Reference: Seattle, Port of, 1996-4-02325      Comments on impacts to wetlands, streams and fisheries resources resulting from proposed 3rd runway and related development actions at Seattle-Tacoma International Airport.

Azous Environmental Sciences (AES) has been retained on behalf of the Airport Communities Coalition to review the impact of the Port of Seattle's proposed development at SeaTac airport on wetlands, streams and fisheries resources. Comments were submitted on the 1999 Wetlands Delineation and Wetland Functional Assessment documents as well as the June 2000 Natural Resources Mitigation Plan and related documents in letters dated August 16<sup>th</sup> and September 1<sup>st</sup> of 2000 to the Department of Ecology and the U.S. Army Corps of Engineers. The purpose of this letter is to provide comments and analyses of the December 2000 updates of these documents. A complete list of materials examined in preparing this critique is provided below.

Figure 1. Functional rankings assigned to wetlands being eliminated for the Third Runway Project.

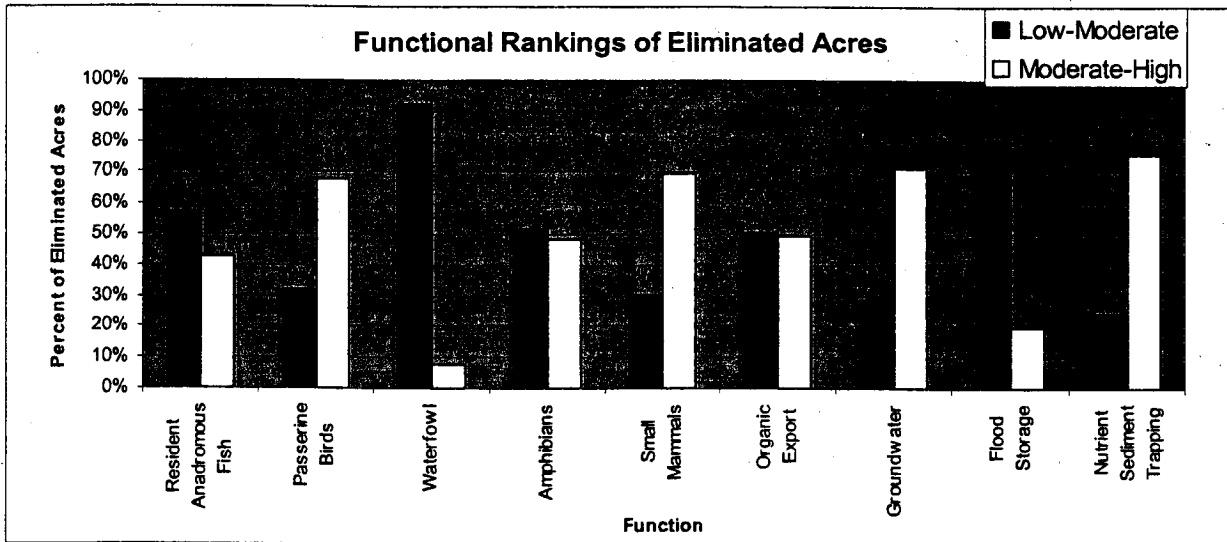
Figure 1 shows that the highest-ranking functions being eliminated from the watershed in the greatest proportion are habitat for passerine birds (68%), small mammals (70%), groundwater discharge/recharge (71%), and nutrient sediment trapping (76%). Forty-three percent of the wetland acres being eliminated are ranked moderate-to-high for anadromous fish habitat, forty-eight percent are ranked moderate-to-high for providing amphibian habitat, and fifty percent are highly valued for export of organic material.

Significantly, 92 percent of the eliminated wetlands are low-to-moderate for waterfowl habitat, and 80 percent are low-to-moderate for flood storage. These are proportionally the *lowest*-ranking functions among all the wetlands being eliminated, yet waterfowl habitat and flood storage are the primary functions targeted for replacement in the NRMP.<sup>2</sup> The grossly misplaced emphasis makes no environmental sense at all and serves to create the impression of mitigation where no effective mitigation in fact exists. The mitigation proposal appears to be tailored to the needs of the project rather than the requirements of the Clean Water Act.

Figure 2. Department of Ecology (DOE) ratings for wetland acres eliminated.<sup>4</sup>

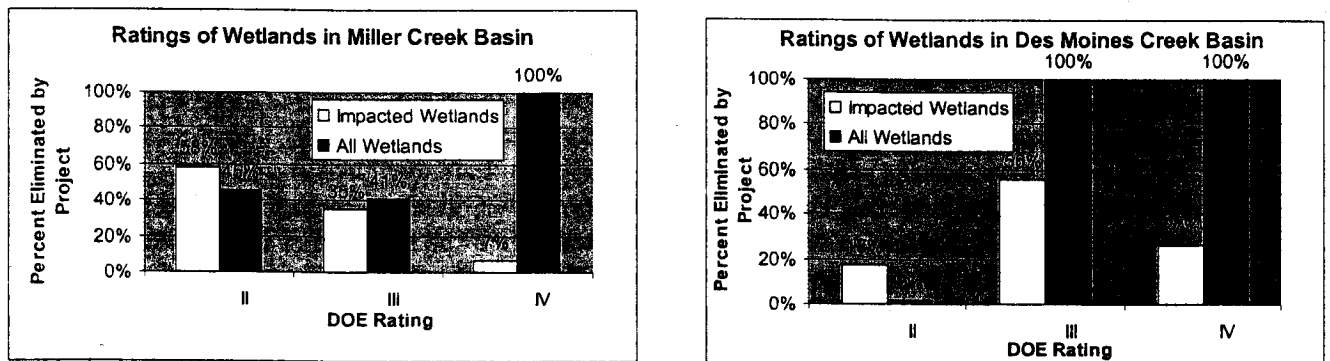
The bar charts in Figure 2 illustrate that the majority of wetland acres being eliminated for the Third Runway project in the Miller Creek watershed are more highly rated Class II wetlands, rather than lower quality Class III and IV wetlands. This evidence directly contradicts the repeated statements

made in the NRMP and Wetland Functional Assessment that the wetlands to be eliminated are degraded to the extent that they provide few valuable functions.<sup>5</sup>

Figure 3. Proportion of wetland habitats eliminated.

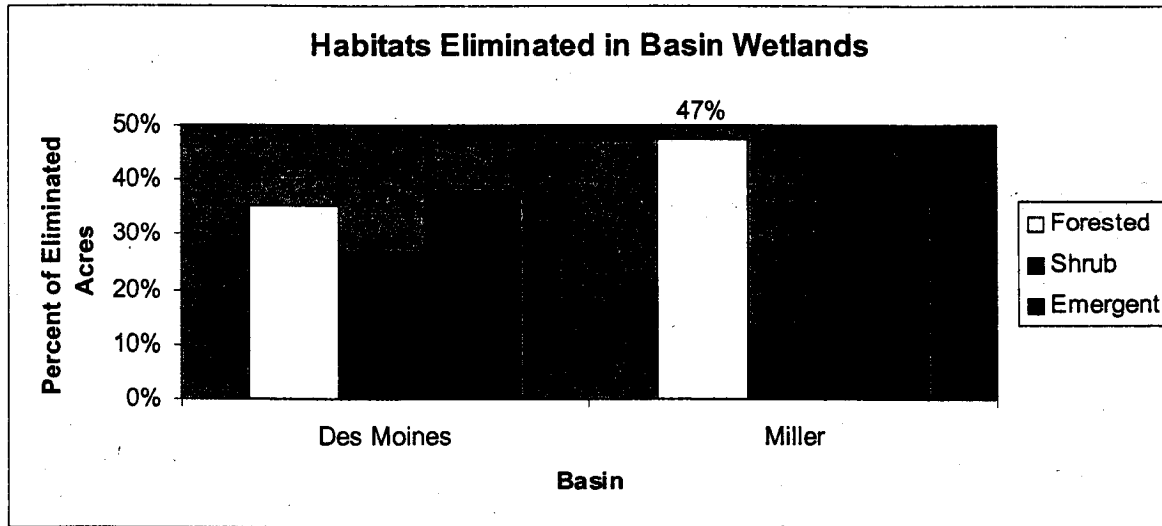
Based on the results revealed in Figures 1, 2 and 3, commensurate mitigation for these lost functions would require replacement of habitat for passerine birds, small mammals, and amphibians. It would require assurances that the sediment and nutrient trapping functions be compensated for, as well as groundwater exchange functions. To comply with Section 404 Guidelines, a plan would have to ensure that sources of organic export within the affected watersheds be maintained and that there be no net loss of fisheries habitat (resident or otherwise), particularly in light of recent and proposed Environmental Species Act (ESA) listings. An acceptable plan would include creation of wetlands rated Class II or greater and would provide habitat dominated by forested and emergent wetland systems.

In contrast, the in-basin mitigation being offered within Miller Creek watershed ignores these key requirements. Instead, the Port proposes to replace the existing wetland functions, identified clearly in the data gathered by its own consultants, with a questionable restoration of a scrub-shrub wetland, the least common habitat type found in the watershed. Further, the restoration is designed to replace "lost" flood plain, which is not identified anywhere in the wetland functional assessment as a significant function provided by the impacted wetlands.

Figure 5a. Wetland 44 boundaries.

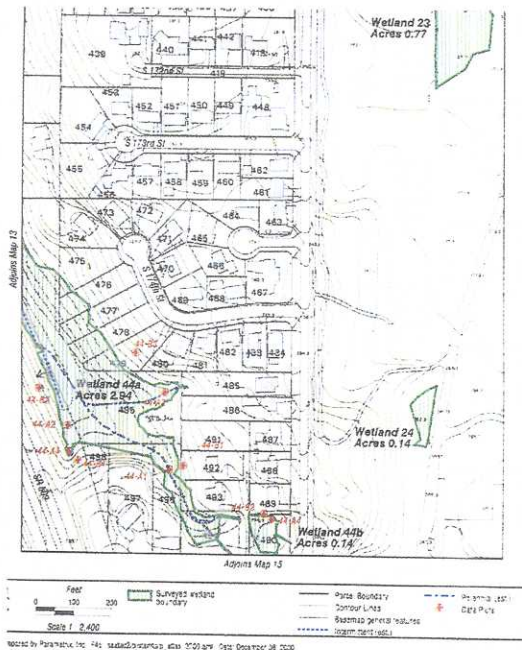
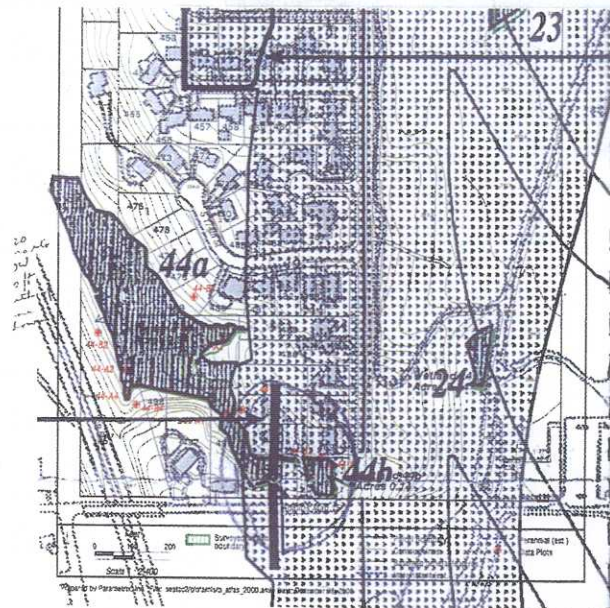
7. The headwater of Walker Creek continues to be incorrectly and inconsistently reported. Map 14 and Image #14 of the December 2000 Wetland Delineation Report show correctly that there are three tributaries to the start of Walker Creek within Wetland 44. These constitute the headwater of Walker

Although the correct information is available in the wetland delineation report, maps of the area in the NRMP shows the headwater of Walker Creek as the outlet of Wetland 43, and the text contained in Section 4.3.2.11 of the Wetland Functional Assessment and Impact Analysis (December 2000) repeats this misrepresentation. The report incorrectly states, "There are no perennial 'headwater seeps' that provide significant base flow to Walker Creek in the area where the embankment fill impacts Wetland 44." In fact, both Map 14 and Image #14 clearly show three tributaries to Walker Creek. Two of them become one perennial stream within the location of the embankment fill. Figure 5a shows the delineated boundary of Wetland 44 presented in Map 14 of the NRMP. Next to it, Figure 5b shows a map of the runway embankment footprint, as shown in Figure 3.1-1 of the NRMP, overlaid on Figure 5a. It shows that the southern-most tributaries are scheduled to be under the embankment fill.

In a previous version of the NRMP (August 1999), Map 10 of the Wetlands Atlas shows Walker Creek originating from the culvert under SR509 and flowing west and northwest until it disappears in under the wetland vegetation (provided in Figure 6a). Curiously, this creek channel, which actually exists, is not shown in the December 2000 Wetland Delineation Report map of Wetland 43 (provided in Figure 6b). This conceals the facts that the embankment construction will fill a portion of the headwaters of Walker Creek and that significant disturbance will occur within the remainder of the headwater wetland from construction activities. This serious harm to the headwater of Des Moines Creek hidden in contradictory reports subverts the permit review process.

Figure 6a. Map 10 from August 1999 NRMP shows Walker creek channel.

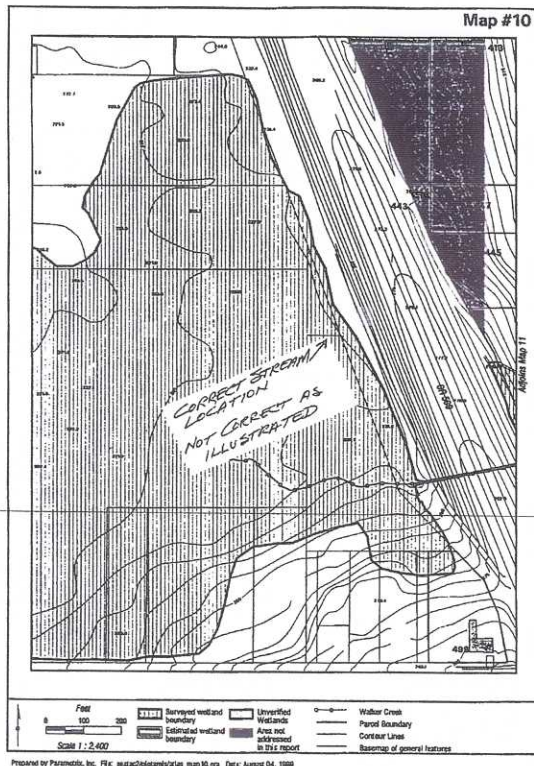
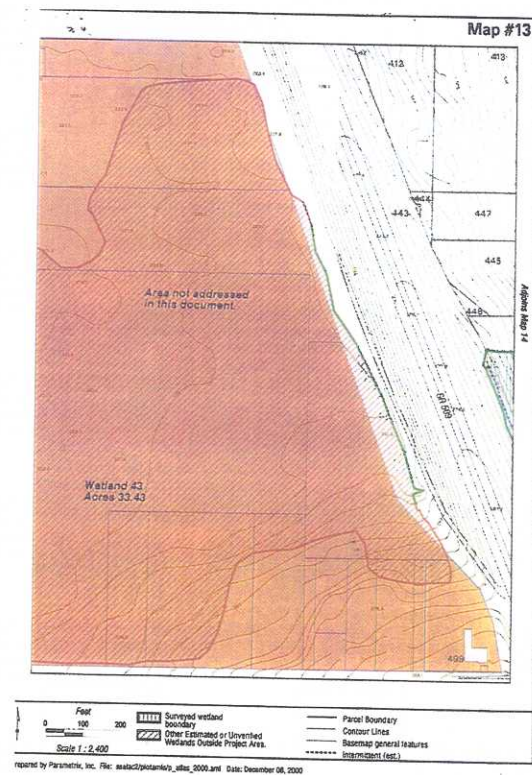
The NRMP states that the stormwater system of SR509 is the headwater to Walker Creek because of its contribution to Walker Creek flows.<sup>25</sup> Although stormwater flows from SR509 may substantially increase Walker Creek, they cannot accurately be construed as the creek headwaters. The landscape position of Wetland 44 in relationship to 43, the presence of a clearly defined channel, and the perennial stream flows cited in the descriptions of Wetland 44 are clear evidence that Walker Creek's headwater is located in Wetland 44 and not in Wetland 43.

Tributary flow volume is an unusual definition of a headwater. Although there are different ways to define a headwater, the generally accepted definition is that a headwater is defined by the furthest upstream tributary (from the mouth) that has a perennial flow. Using this more appropriate definition, Wetland 44 and its tributaries comprise the Walker Creek's headwater. Headwater wetlands and tributary seeps have an important ecologic and hydrologic role in maintaining function in a creek system and are protected for that reason. Filling a headwater wetland will alter a stream's condition profoundly. The runway embankment fill will negatively affect the Walker Creek system by filling the upland seeps and portions of the wetland that comprise Walker Creek's true headwater.
